Responsible: D. Rutz
Date: 11.02.2009

EDG 6400.0

Digital programmer software bug in descaling function

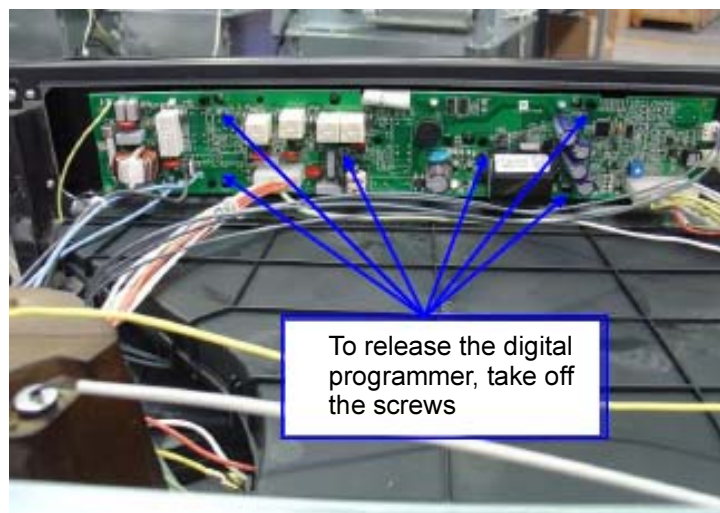
This fault only appears when there's the first need for descaling. At that time and because of this bug, the oven will be blocked (prevented from working) even if the user runs several descaling cycles.

Replace the digital programmer for a new one. The version of the software is mentioned in the characteristics label attached to the digital programmer as following:

- 1.0 – Software with bug
- 1.1 –Software with correction

Spare parts N. 534 726
